**OHIO RIVER BRIDGES
SECTION 1 - KENNEDY INTERCHANGE
VALUE ENGINEERING STUDY REPORT**

Item Number 5-118.18 & 5-118.19

**Study Date: January 28 - February 1, 2008
Report Date: February 15, 2008**

**VALUE ENGINEERING STUDY
for
Kentucky Transportation Cabinet**

VALUE ENGINEERING RECOMMENDATION # VE-1

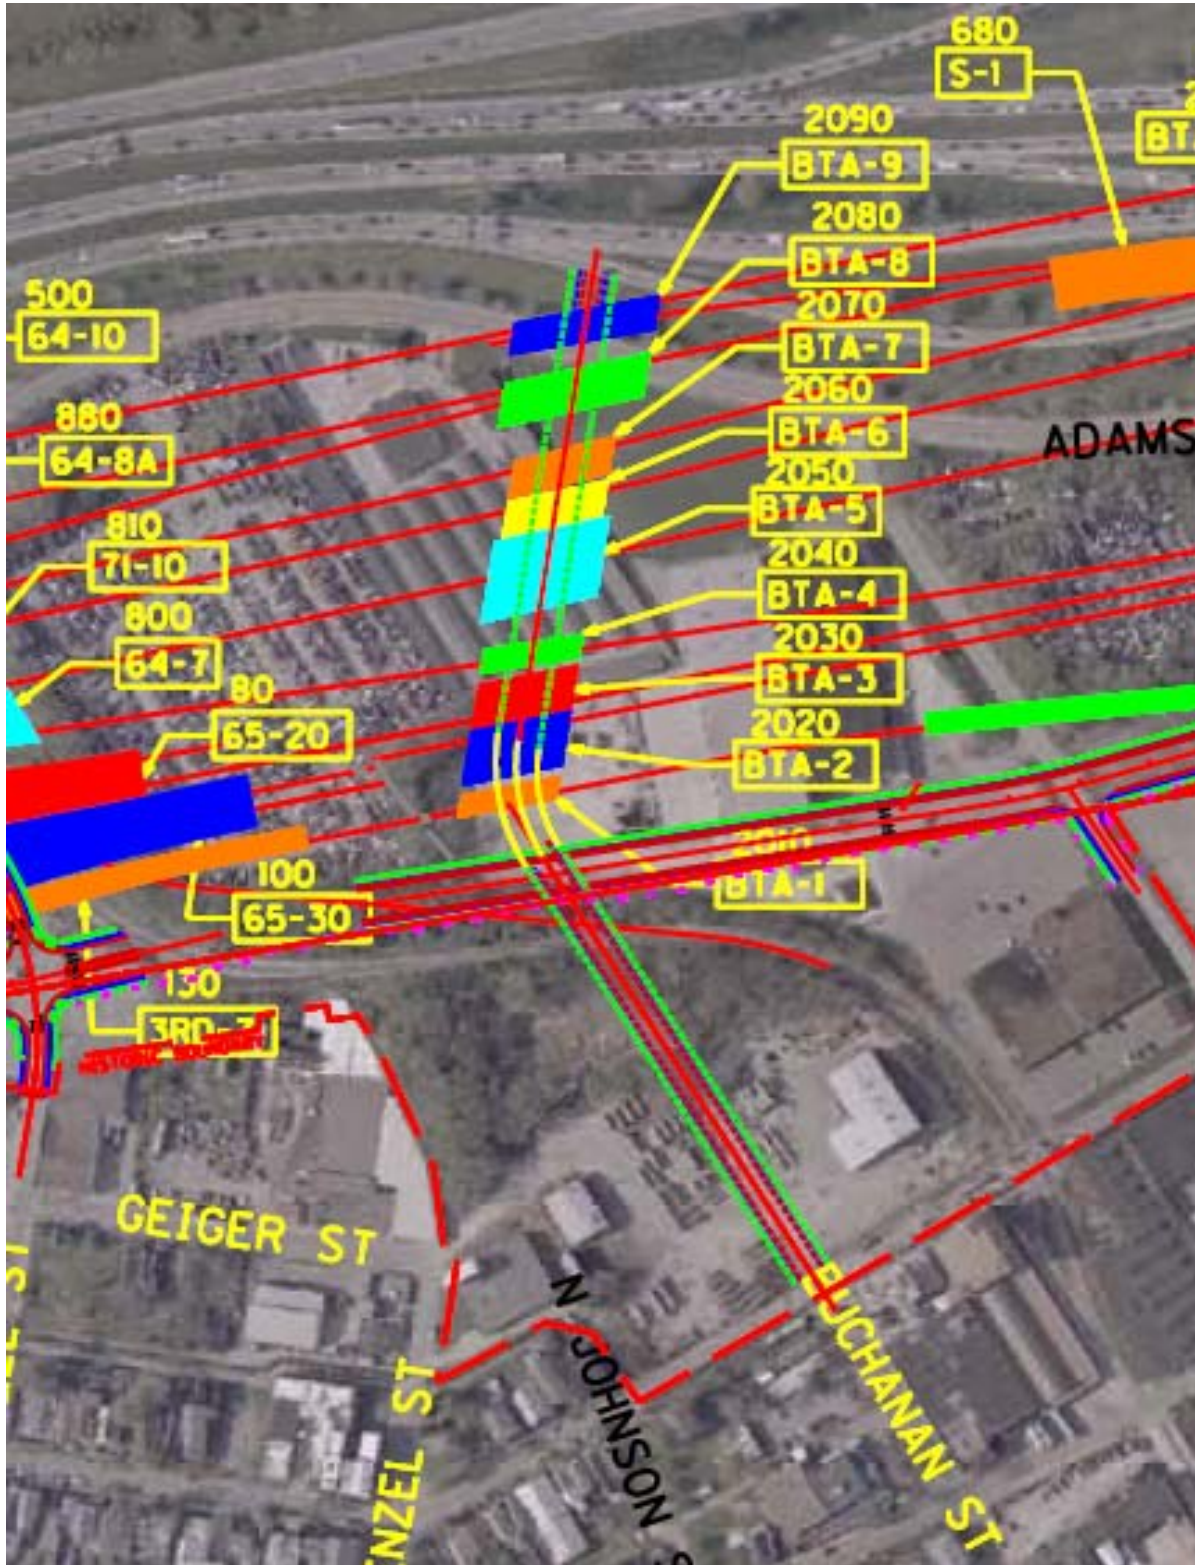
The original design specifies Buchanan Street connecting from Witherspoon Street to River Road. The existing Buchanan Street currently ends at Franklin Street. The original design extends Buchanan Street below 9 new bridges (BTA-9, BTA-8, BTA-7, BTA-6, BTA-5, BTA-4, BTA-3, BTA-2, and BTA-1). These nine bridges are not listed on the cost estimate or the Bridge Data sheet provided to the VE team, so assumptions had to be made. The 9 bridges carry over 22 lanes of traffic and all appear to be an average of 100 ft long.

The current construction estimate does not reflect a cost for these 9 bridges, but they are identified on the LSIORB Kennedy Interchange Proposed Brides document dated February 2007. The connection from Buchanan to River Road does not currently exist today. The VE team feels it is not prudent to construct these 9 bridges to create a new access, when there will already be access provided by Campbell Road 700 ft to the west and Adams Street 1,700 ft to the east. Other connections from Witherspoon to River Road that are designed within this interchange include Preston Street, Clay Street, and Frankfort Street. This makes a total of 6 connections between Witherspoon and River Road within a 3,100 ft.

It has become evident to the VE team that the only reason this project is constructing these 9 new bridges is to satisfy a recommendation made in the Butchertown Historical Preservation Plan (HPP). The recommendation in the HPP encourages more connections between Butchertown and the Ohio River. The existing condition only provides 2 overall connections, and the original design of the project now provides 6 connections. The VE team suggests eliminating one or more of these connections, which shouldn't be considered a violation of the HPP. The VE team feels that not all recommendations of the HPP are required to be implemented to satisfy the ROD.

VALUE ENGINEERING RECOMMENDATION # VE-2
SKETCH OF ORIGINAL DESIGN

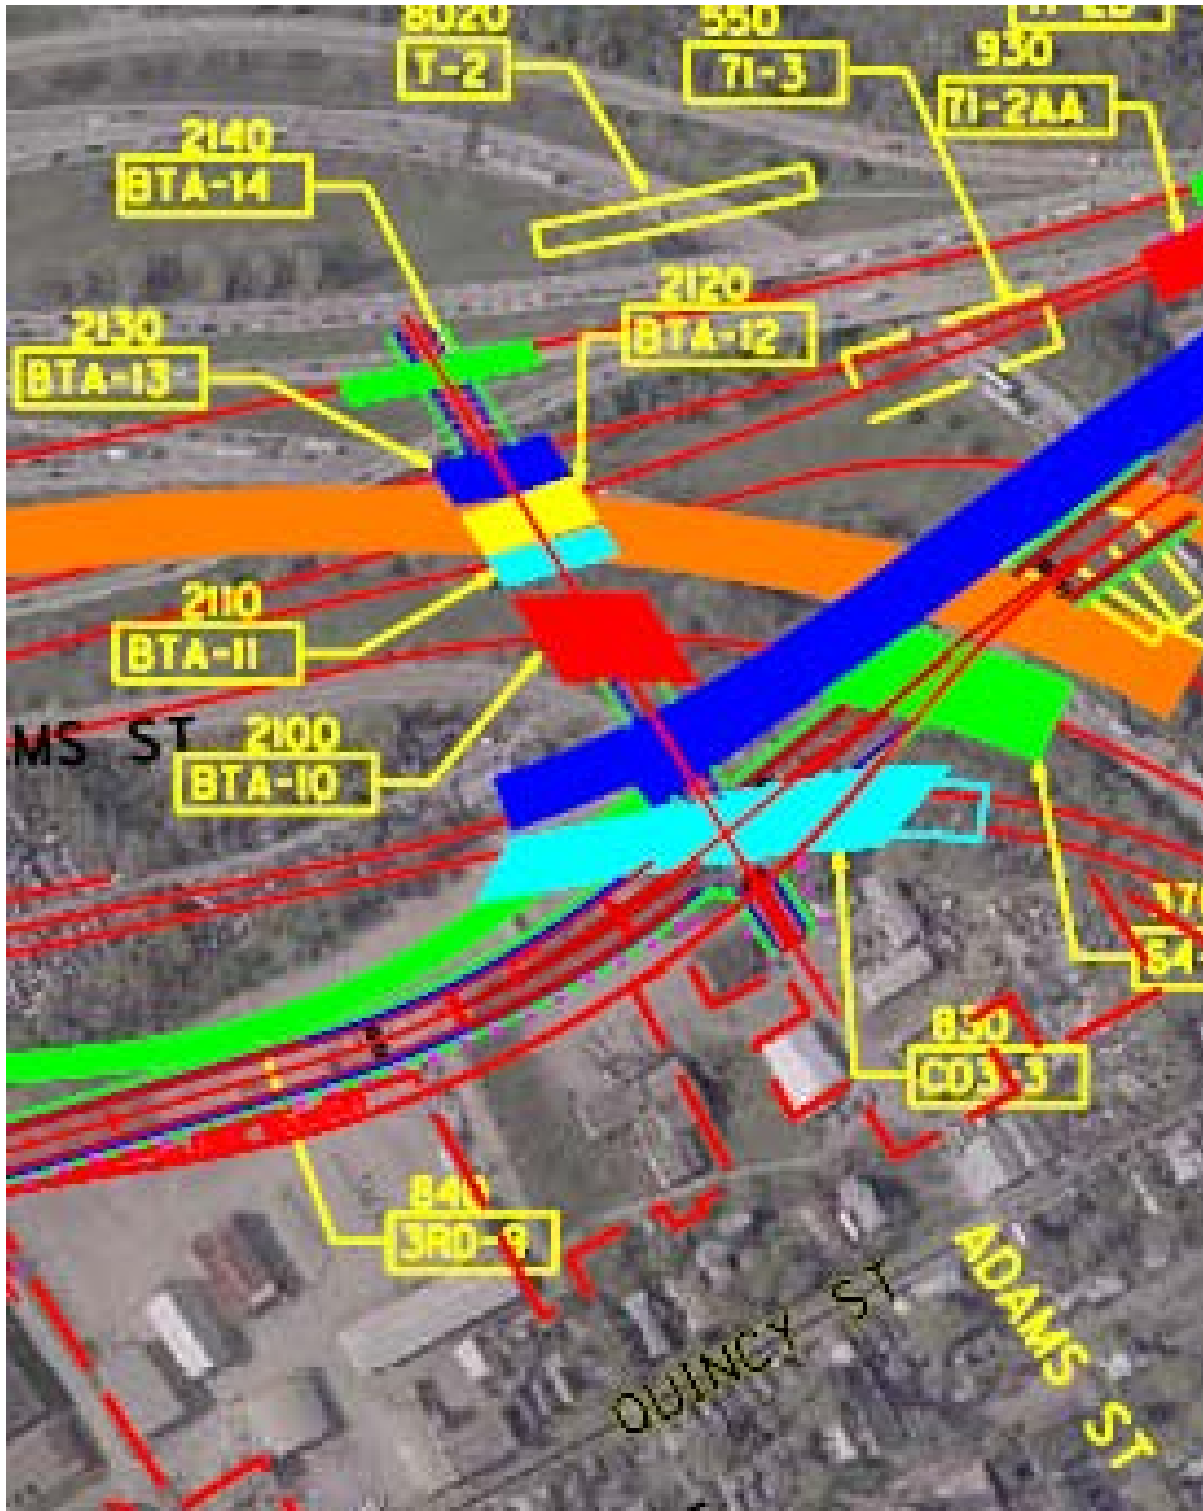
The original design specifies Adams Street connecting from Witherspoon Street to River Road. The existing Adam Street currently follows I-64 alignment to the west and terminates at Campbell Street. The original design extends Adams Street below 9 new bridges (BTA-10, BTA-11, BTA-12, BTA-13, BTA-14, CD3-3, 3RD-9, CD3-1, S-1). At least 4 of these bridges are exclusively to span Adams Street. Theses 4 bridges are not listed on the cost estimate or the Bridge Data sheet provided to the VE team, so assumptions had to be made. The 4 bridges carry over at least 10 lanes of traffic and all appear to be an average of 100 ft long.

It has become evident to the VE team that the only reason this project is constructing these 4 new bridges is to satisfy a recommendation made in the Butchertown Historical Preservation Plan (HPP). The recommendation in the HPP encourages more connections between Butchertown and the Ohio River. The existing condition only provides 2 overall connections, and the original design of the project now provides 6 connections. The VE team suggests eliminating one or more of these connections, which shouldn't be considered a violation of the HPP. The VE team feels that not all recommendations of the HPP are required to be implemented to satisfy the ROD.

VALUE ENGINEERING RECOMMENDATION # VE-6

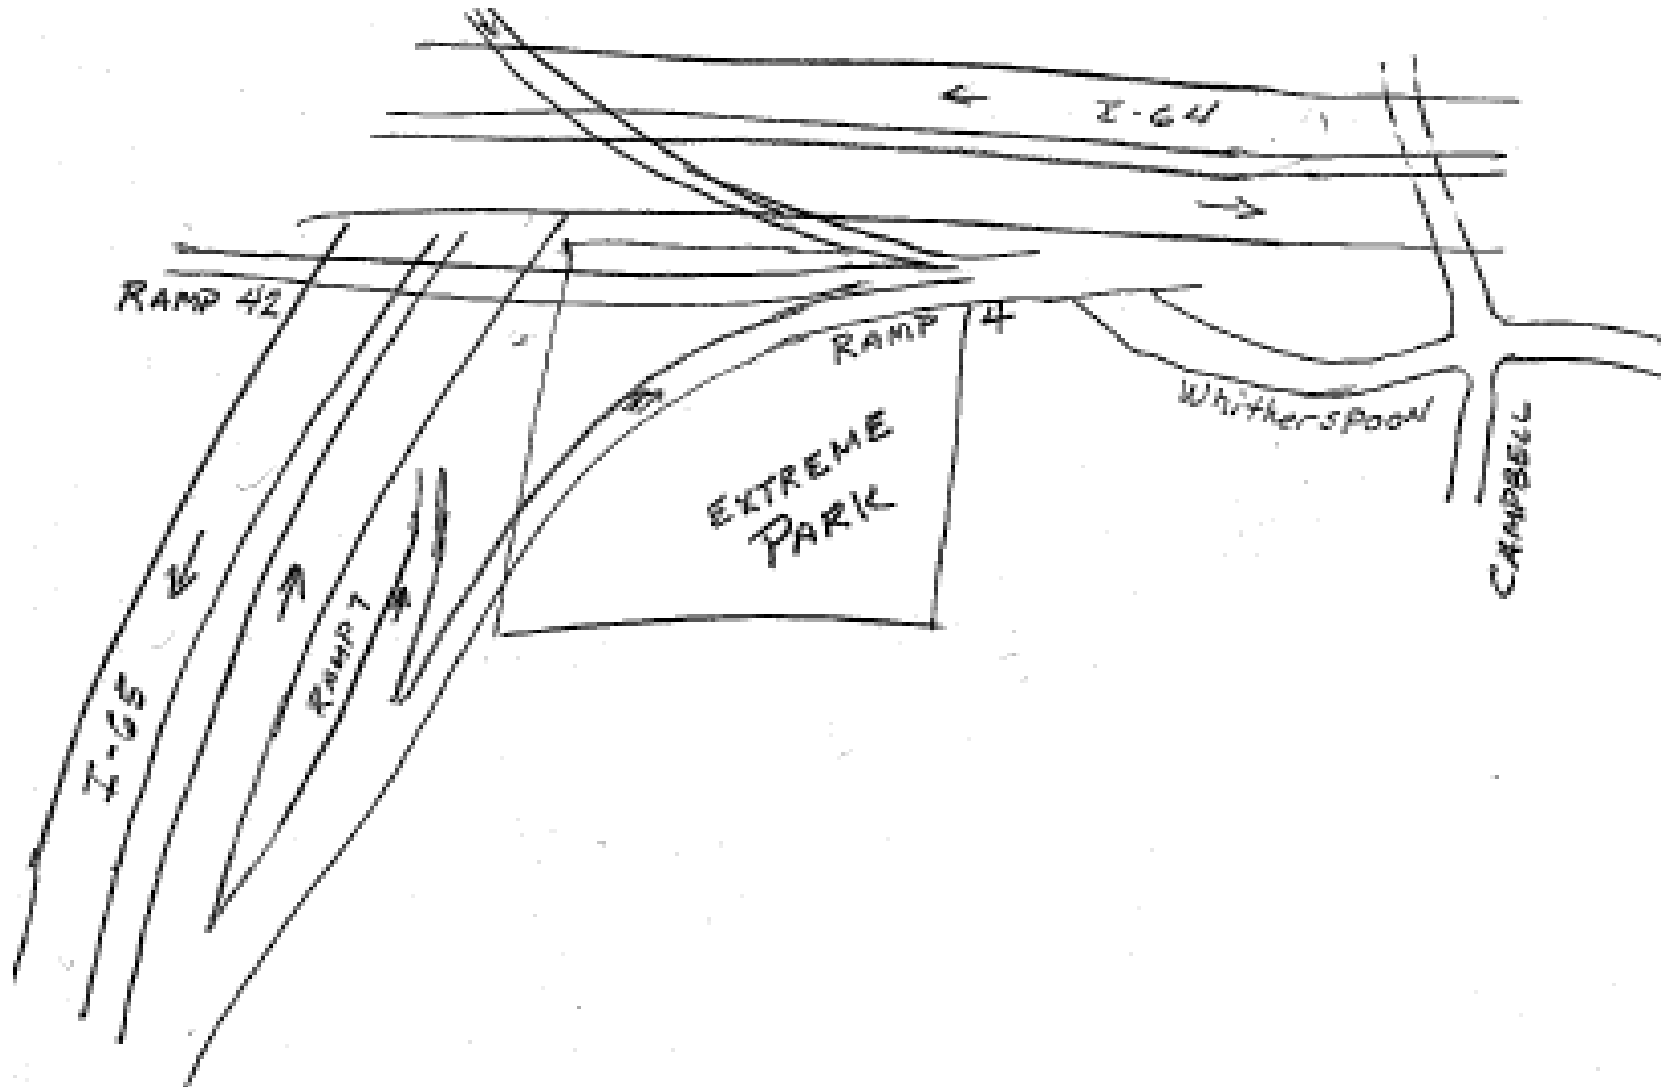
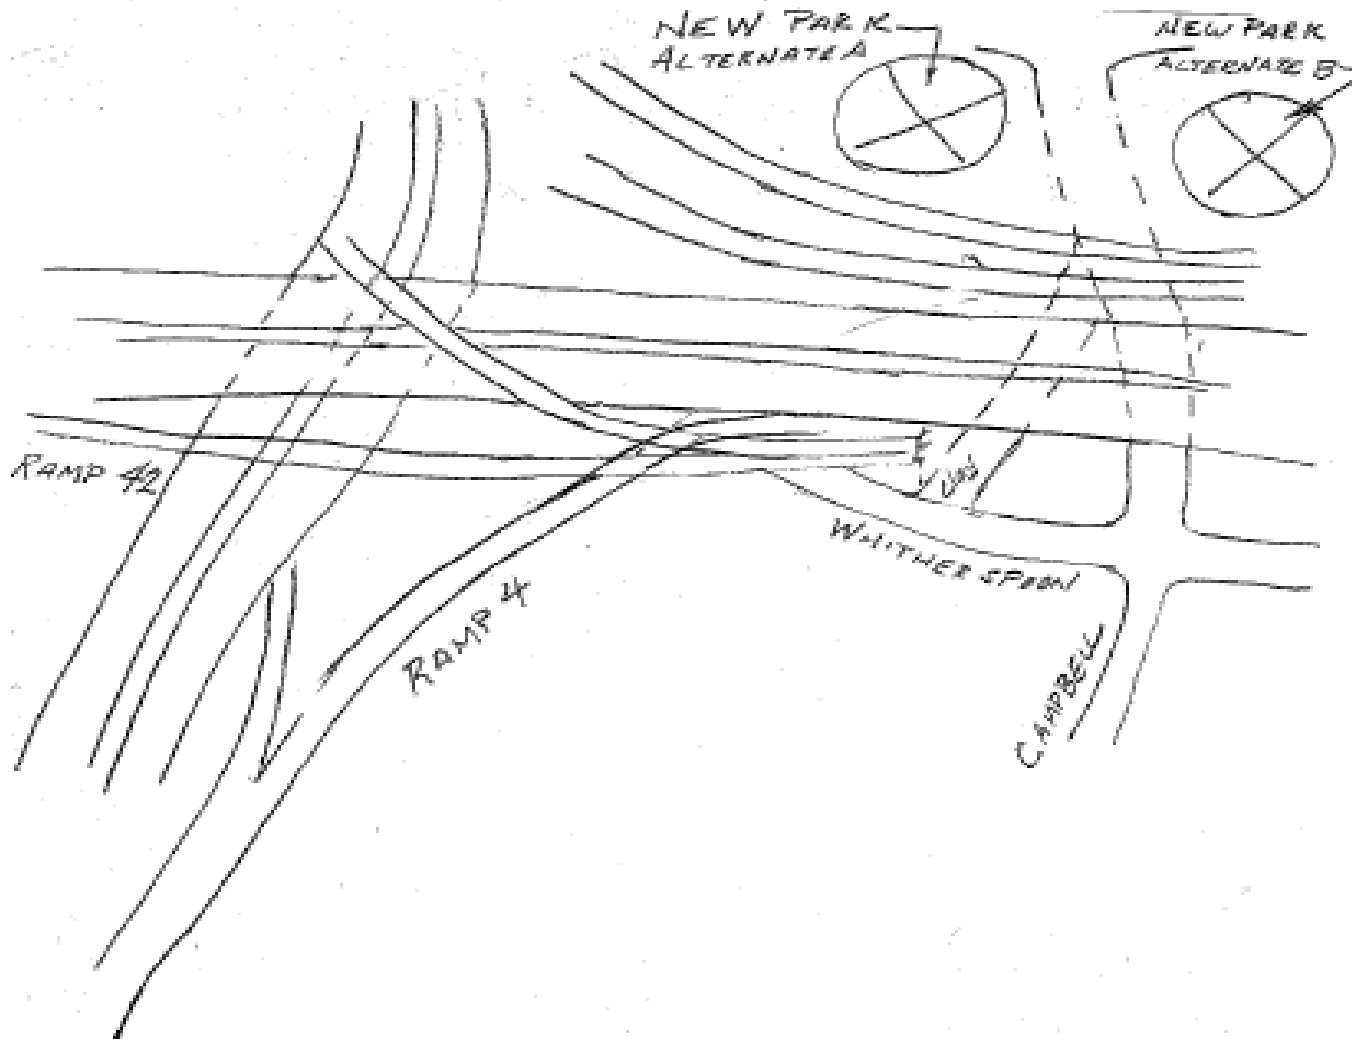
The current design keeps Extreme Park in its current location. Ramp 4 profile is adjusted to provide clearance over the park requiring a bridge over the park. This also requires grade adjustments for Ramp 42. Witherspoon is moved to the north, under Ramp 4, 6, 9 and 42.

- Shorten bridge 65-31
- Would allow alignment of Witherspoon Street to be shifted south reducing or eliminating several bridges and ramps
- Improves Witherspoon Street connection along the north side of Butchertown thus tying the area together better
- A new rebuild park could be bigger and better

VALUE ENGINEERING RECOMMENDATION # VE-8

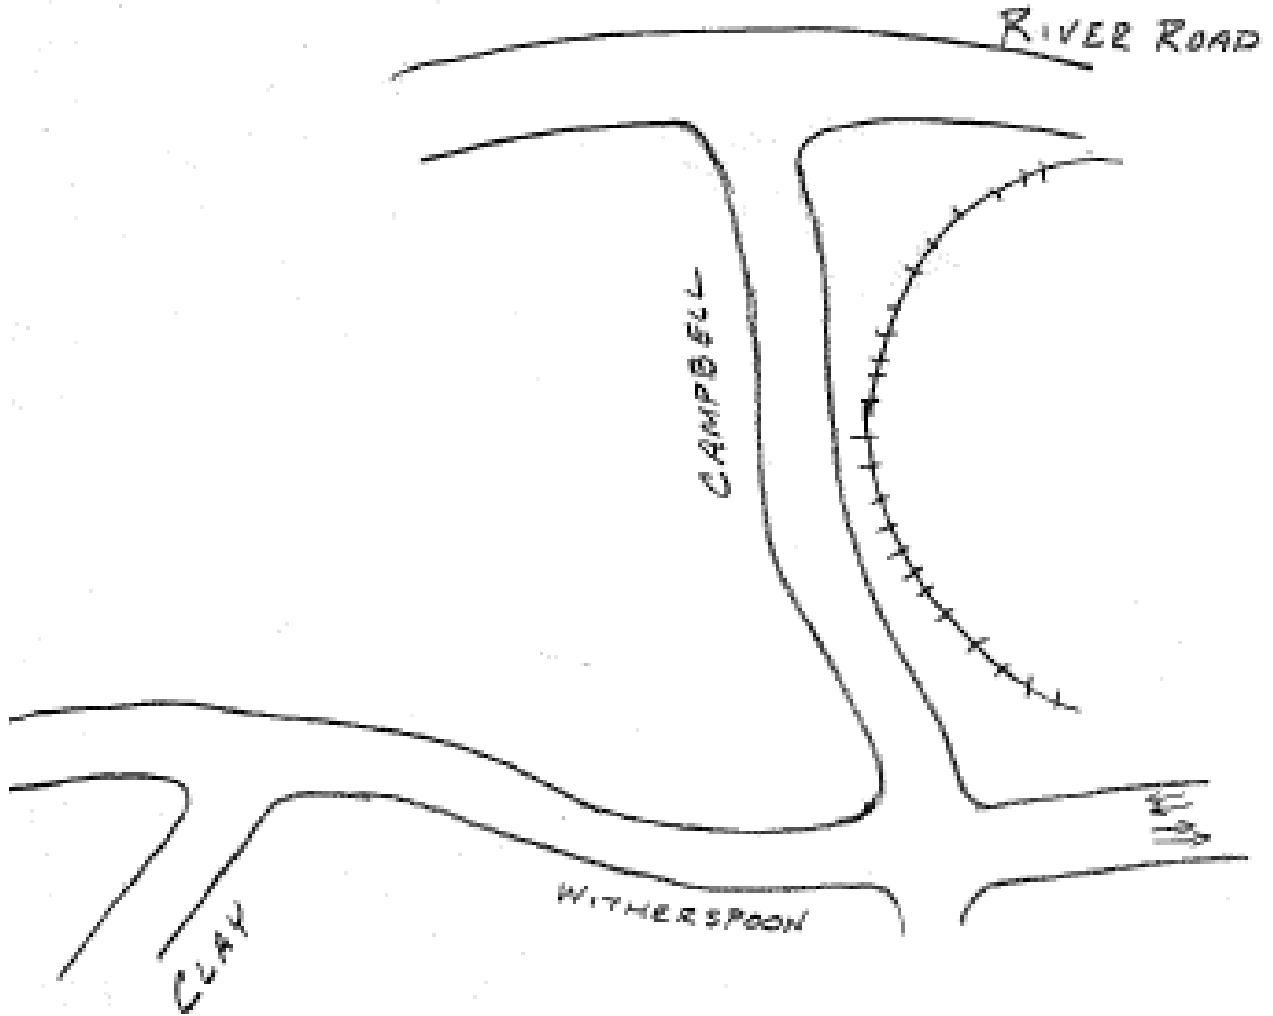
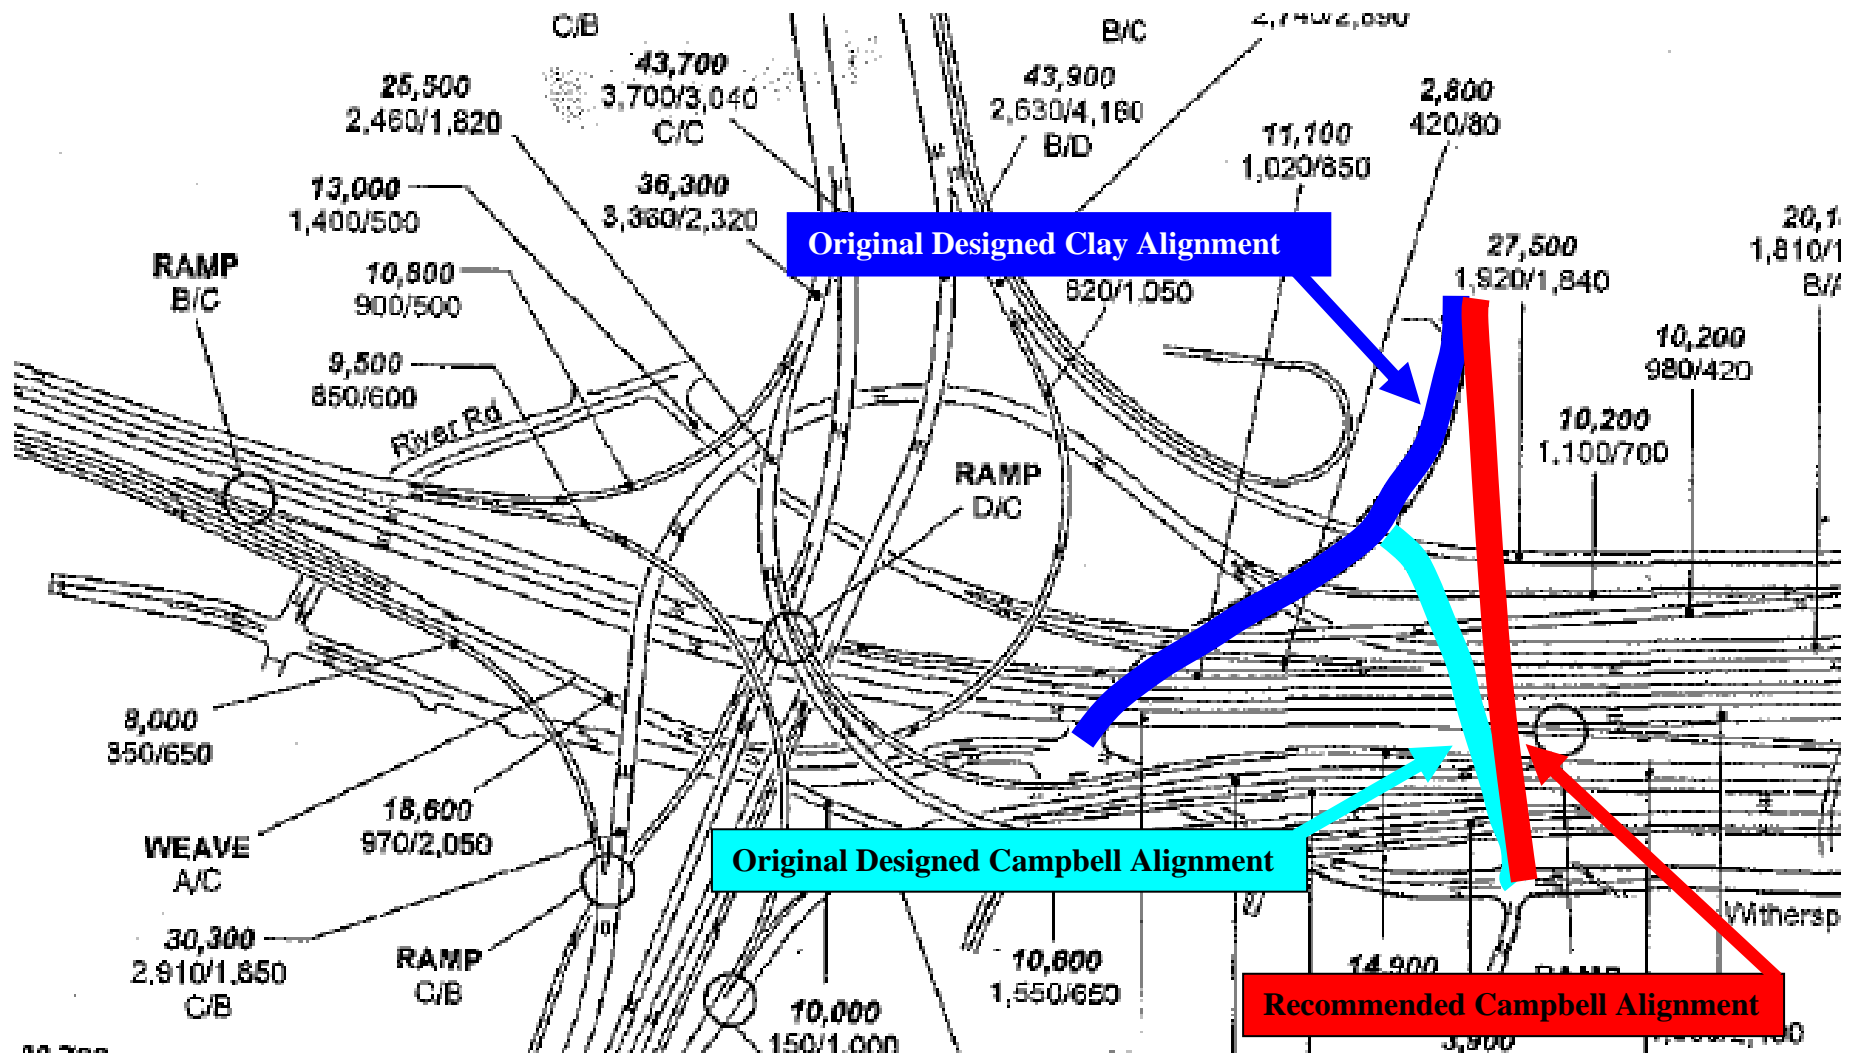
Eliminate Clay from Witherspoon to Campbell Street. Shorten or eliminate bridges over Clay. Re-align Campbell to parallel to the railroad and straighten Campbell and connect to River Road. This change will require coordination with the Butchertown Historic Preservation Plan group.

- Eliminates or shortens approximately 7 bridges.
- Eliminates 5213 SY of pavement, 770 SY of sidewalk, and 1380 LF of standard curb and gutter.
- Maintains visual access from Butchertown via Campbell Street
- Provides better street alignment under I-64
- Frees up additional property for park use or green space
- Reduces perpetual maintenance costs of the Kennedy Interchange bridge that are eliminated and/or shortened
- Reduce maintenance due to deletion of Clay Street
